SUBJECT: Hold a public meeting for a Development Plan Review for CHURCH ON MILL located at 1300 South Mill Avenue.

DOCUMENT NAME: DRCr_Churchonmill_081407 **PLANNED DEVELOPMENT (0406)**

COMMENTS: Request for **CHURCH ON MILL – CLASSROOM BUILDING (PL070066)** (First Southern Baptist Church of Tempe, owner; Joel Nice, Bardusen Architects, applicant) for a +/-14,600 s.f. classroom and administration building added to an 13,932 s.f. worship and ministry campus on +/- 3.16 acres, located at 1300 S. Mill Avenue, in the R-2, Multi-family Residential District. The request includes the following:

DPR07139 – Development Plan Review including building elevations, site plan and landscape plan for a one-story classroom and administrative building built in an L-shape on the south side of the lot.

ARCHITECTURAL SITE PLAN

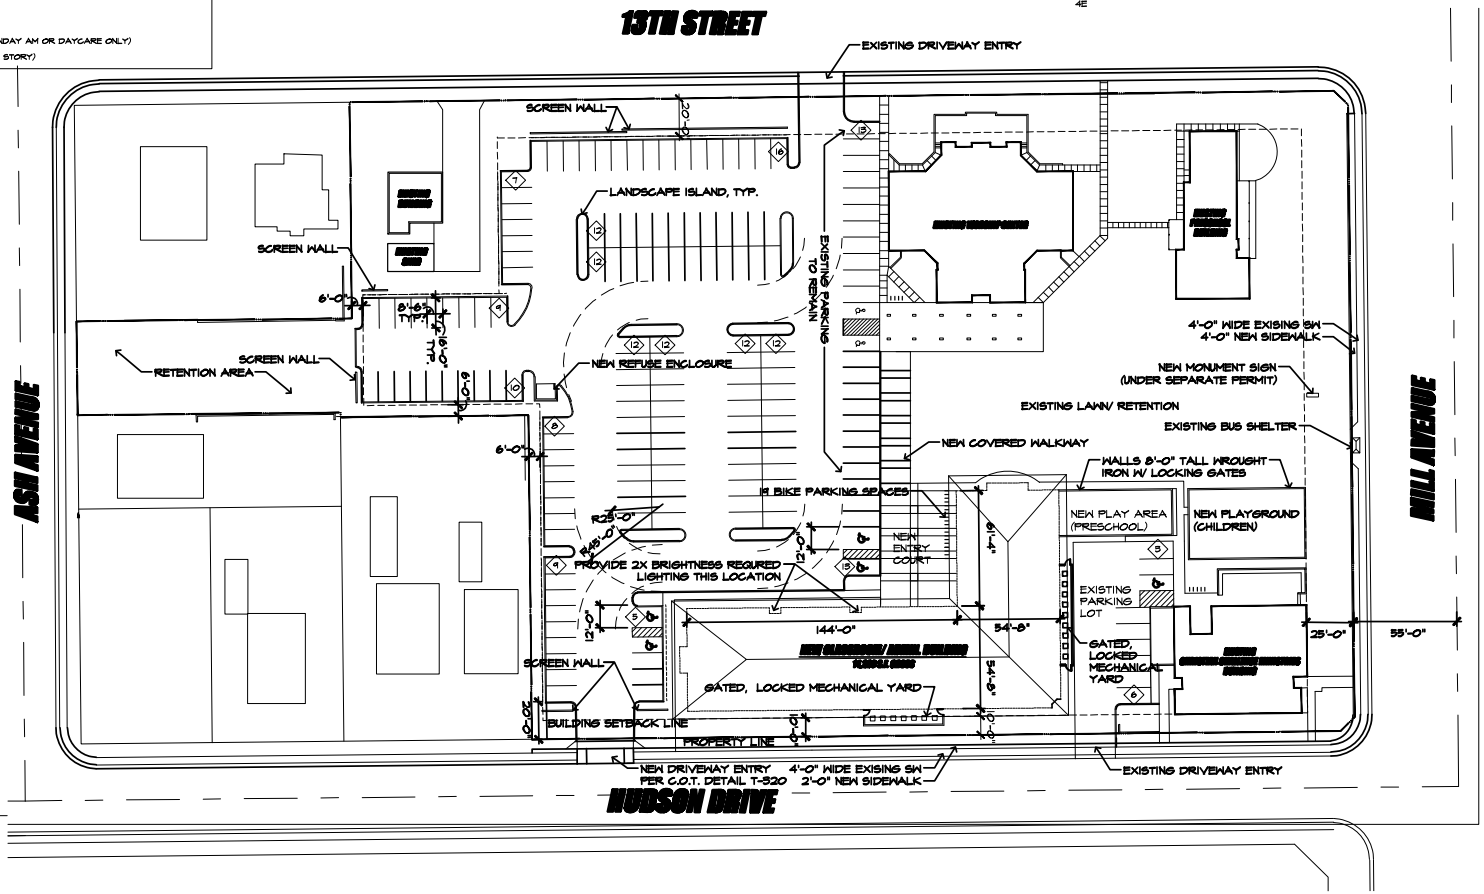
4. Provide 8'-0" wide public sidewalk along Mill Avenue and a 6'-0" wide sidewalk along Hudson Lane as required by Traffic Engineering Design Criteria and Standard Details.

5. Provide service yard and mechanical yard walls internal to the site; that are at least 8'-0" tall as measured from adjacent grade and are at least the height of the equipment being enclosed, whichever is greater. Verify height of equipment and mounting base to ensure that wall height is adequate to fully screen the equipment. Locate electrical service entrance sections inside the service yard, as indicated.

6. Provide upgraded paving at each driveway apron consisting of unit paving. Extend unit paving in the driveway from the back of the accessible public sidewalk bypass to 20'-0" on site and from curb to curb at the drive edges.

7. Place exterior, freestanding reduced pressure and double check backflow assemblies in pre-manufactured, pre-finished, lockable cages (one assembly per cage). If backflow prevention or similar device is for a 3" or greater water line, delete cage and provide a masonry or concrete screen wall following the requirements of Standard Detail T-214.

- Driveways:
  - Construct driveways in public right of way in conformance with Standard Detail T-320.
  - Correctly indicate clear vision triangles at both driveways on the site and landscape plans. Identify speed limits for adjacent streets at the site frontages. Begin sight triangle in driveways at point 15'-0" in back of face of curb. Consult "Corner Sight Distance" leaflet, available from Development Services Counter or from John Brusky in Transportation (480-350-8219) if needed. Do not locate site furnishings, screen walls or other visual obstructions over 2'-0" tall (except canopy trees are allowed) within each clear vision triangle.

A3-1

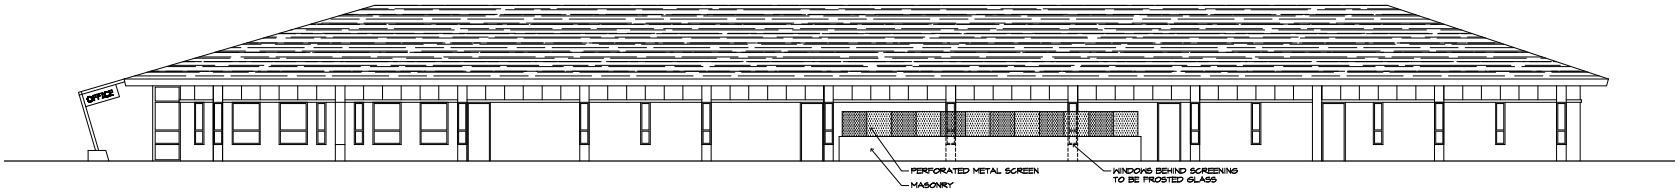
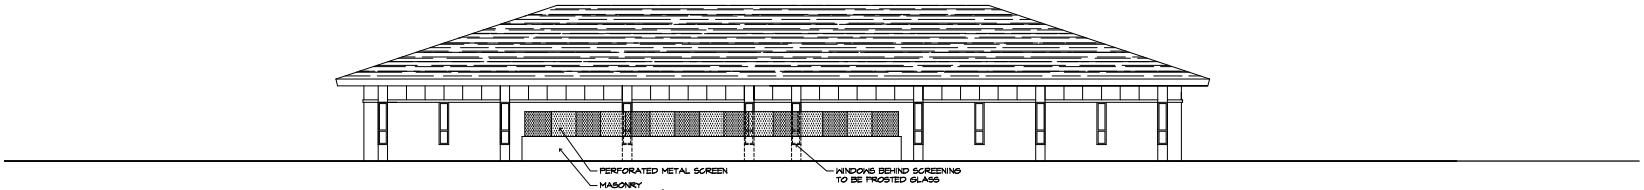
10. Provide main colors and materials with a light reflectance value of 75 percent or less. Specific colors and materials exhibited on the materials sample board are approved by planning staff. Submit any additions or modifications for review during building plan check process. Planning inspection staff will field verify colors and materials during the construction phase.

11. Provide secure roof access from the interior of the building. Do not expose roof access to public view.

12. Conceal roof drainage system within the interior of the building. Minimize visible, external features, such as overflows, and where needed design these to enhance the architecture of the building.

14. Locate the electrical service entrance section (S.E.S.) inside the building or inside a secure yard that is concealed from public view.

15. Exposed conduit, piping, etc. is not allowed unless a creative conduit surface design that compliments the architecture is reviewed and approved by the Development Review Commission.

A2-1

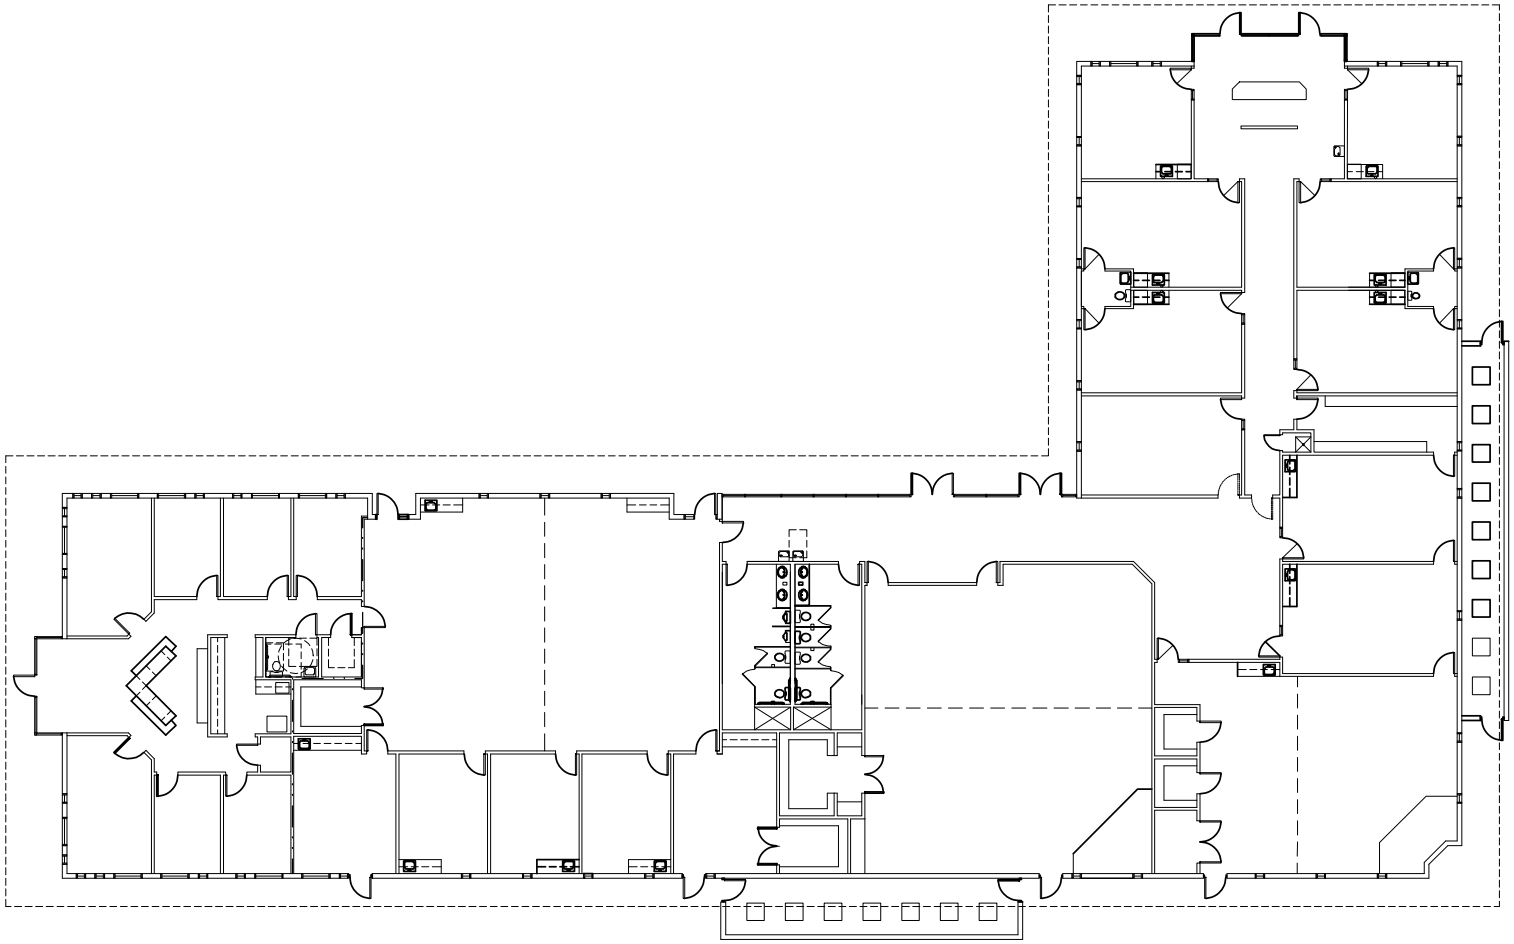
9. In instances where an exit is within 21'-0" of an alcove, corner or other potential hiding place, position a refracting mirror to allow someone in the exit doorway to observe in the mirror the area around the corner or within the alcove that is adjacent to the doorway.

- A security vision panel shall be provided at service and exit doors (except to rarely accessed equipment rooms) with a 3" wide high strength plastic or laminated glass window, located between 43" and 66" from

CONCEPTUAL PLANTING PLAN

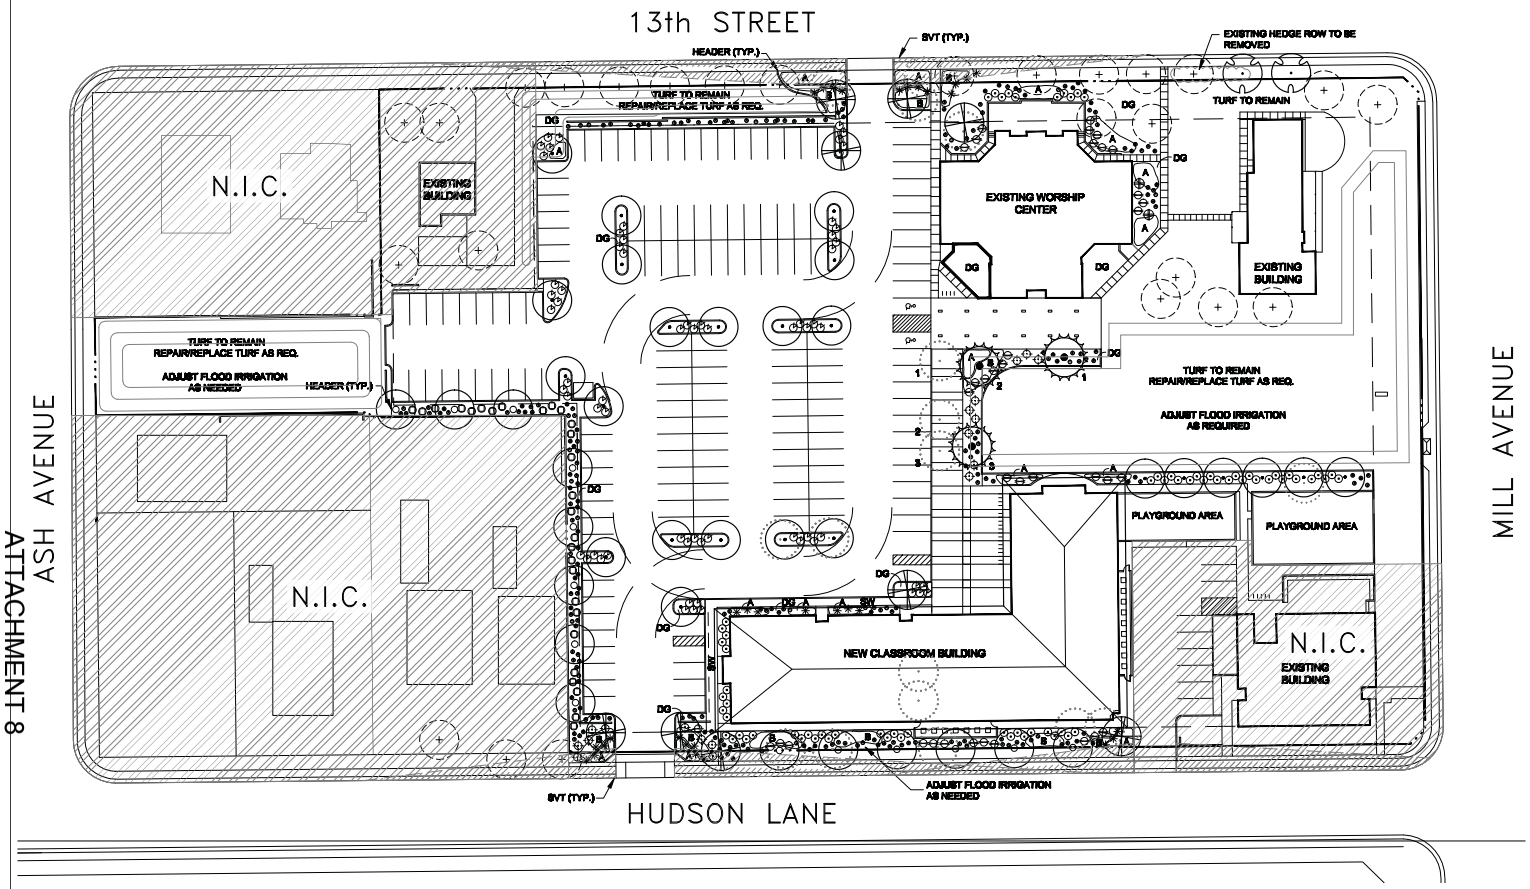
17. Irrigation notes:
    a. Enclose backflow prevention device in a lockable, pre-manufactured cage.
    b. Provide pipe distribution system of buried rigid (polyvinylchloride), not flexible (polyethylene). Use of schedule 40 PVC mainline and class 315 PVC ½” feeder line is acceptable. Class 200 PVC feeder line may be used for sizes greater than ½” (if any). Provide details of water distribution system.
    c. Locate valve controller in a vandal resistant housing.
    d. Hardwire power source to controller (a receptacle connection is not allowed).
    e. Controller valve wire conduit may be exposed if the controller remains in the mechanical yard.
    f. Repair existing irrigation system (on site or in the adjacent public right of ways) where damaged by work of this project. Provide temporary irrigation to existing landscape (on site or in these frontages) for period

18. Include requirement in site landscape work to de-compact soil in planting areas on site and in public right of way and remove construction debris from planting areas prior to landscape installation.

19. Top dress planting areas with a rock or decomposed granite application. Provide rock or decomposed granite of 2" uniform thickness or less. Provide pre-emergence weed control application and do not underlay rock or decomposed granite application with plastic.

PHOTOMETRIC SITE PLAN

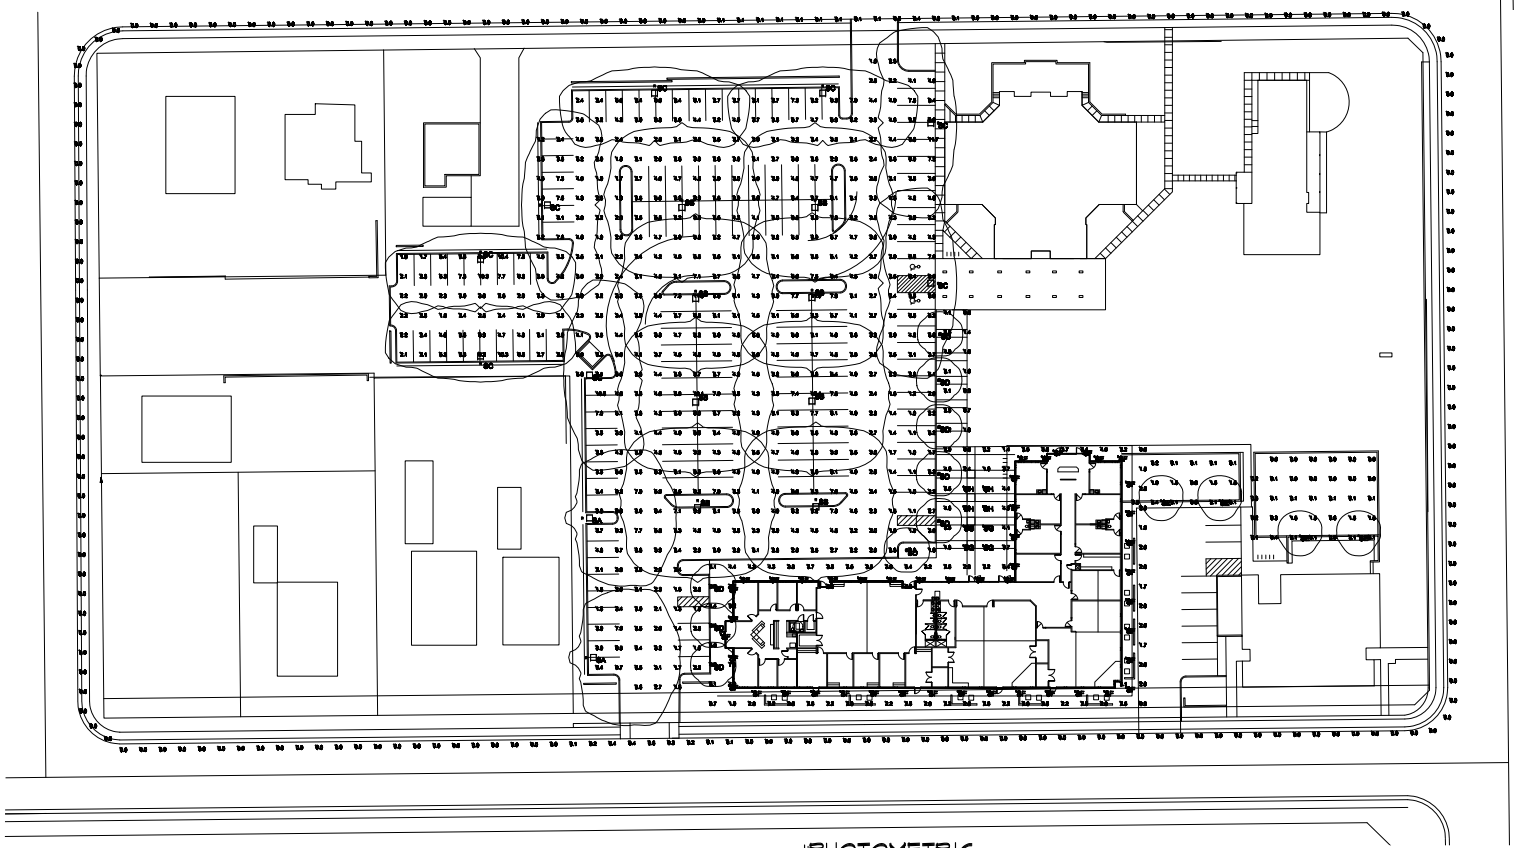
16. Illuminate building entrances and underside of open stair landings from dusk to dawn to assist with visual surveillance at these locations (review the lighting section & see what items in your case are not covered).
